Flight Procedures Cover Page	Task Action: FLIGHT CHECK	Task Type: IAP	Estimated Chart Date: 08/10/2023	APWS Task ID: DE7F41927591422CA01093C3D0563D28	APWS Project ID: FC16BD4BFFC24C12BEB64F38D724E47B
Procedure: RNAV (GPS) Z RWY 19 AMDT 2		Enroute: NO	Specialist: Copeland, Guy		Agreement Number:
Airport ID: KMKC			Airport City: KANSAS CITY		State: MO
Facility ID:	Facility Type:	Flight Inspection Remark Type: New FC Slot			
<div>Procedure Comments: CONTACT: DAVID TEFFETELLER 202-267-5177</div> <div>AMENDMENT</div> <div>DUE TO PREVIOUS MAG VAR UPDATE EFFECTING KMKC RWY</div> <div>NUMBERING. THIS CANCELS NOTAM FDC 1/5124</div> <div>NEW CRC REMAIDER FROM 5A709CD0 TO F4403F20</div> <div>06/08/2023: THIS IS A CORRECTED COPY OF THE FORM APPROVED ON 05/17/2023.</div> <div>1. MOVED SINGLE ASTERISK FROM LPV DA 1097 LINE TO LPV DA LINE 1004.</div> <div>2. MOVED DOUBLE ASTERISK FROM LNAV/VNAV DA LINE 1468 TO LNAV/VNAV DA LINE 1077.</div> <div>QUALITY 16 CHECKED</div> <div>QUALITY 41 CHECKED</div> <div>J ZEDER 05/12/2023</div>

FIPC BASIC FORM						
PROCEDURE: RNAV (GPS) Z RWY 19 AMDT 2			AIRPORT NAME: CHARLES B WHEELER DOWNTOWN		AIRPORT ID: KMKC	SPECIAL CONTROL NO: OG-06-141-23
FAC ID: KMKC19.0

AUTOMATED AL-213 RNAV (GPS) Z RWY 19

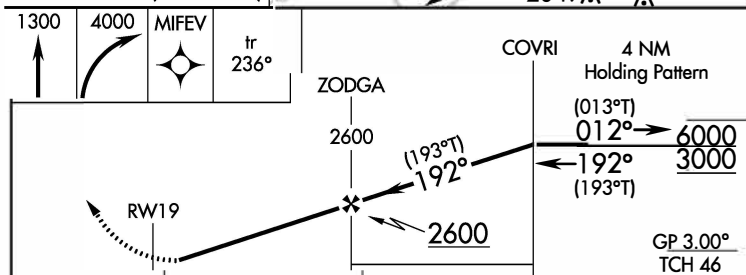
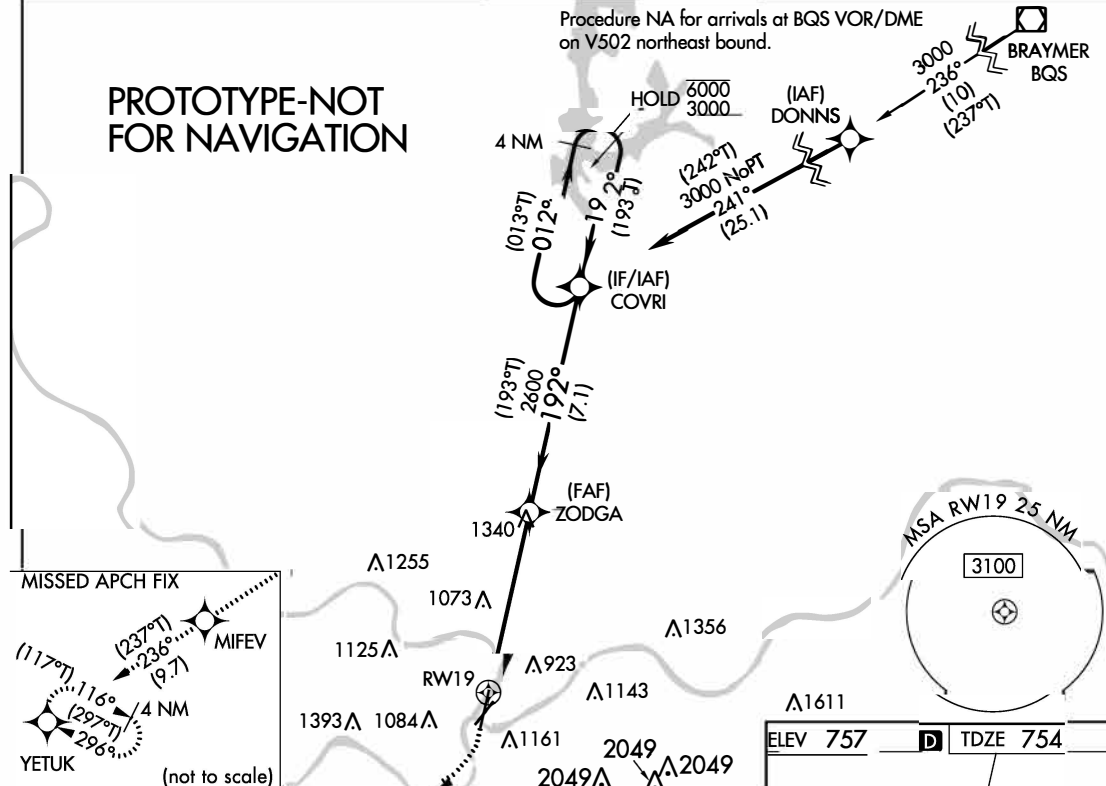
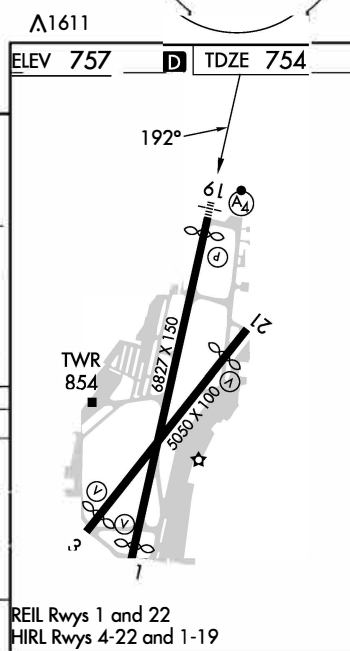
FLIGHT INSPECTOR SIGNATURE: gregory mills @ 06/28/2023 20:57			PRINTED NAME: MILLS, GREGORY ALAN			NOTAM INITIATED? <input type="checkbox"/> YES <input checked="" type="checkbox"/> NO
FLIGHT INSPECTOR REMARKS: SAT w/changes. If kept the minima with asterisks should be the lower minima. Higher minima has less altitude to climb to altitude and starts the missed further from the obstacle. Also the LPV minima requiring the CG should not be kept as it gives less than 100 ft benefit						
IN-FLIGHT OBSTACLE REPORT						
OBSTRUCTION ID #:	COORDINATES OR LOCATION:	GNSS ALTITUDE (MSL):	BAROMETRIC ALTITUDE (MSL):	HEIGHT ABOVE GROUND LEVEL:

FLIGHT INSPECTOR REMARKS: Two lines of minima for LPV and LNAV/VNAV. On one approach plate with climb gradients for one line and not for another. Even if that is correct it is not clear to which line the climb gradient corresponds to.						
IN-FLIGHT OBSTACLE REPORT						
OBSTRUCTION ID #:	COORDINATES OR LOCATION:	GNSS ALTITUDE (MSL):	BAROMETRIC ALTITUDE (MSL):	HEIGHT ABOVE GROUND LEVEL:
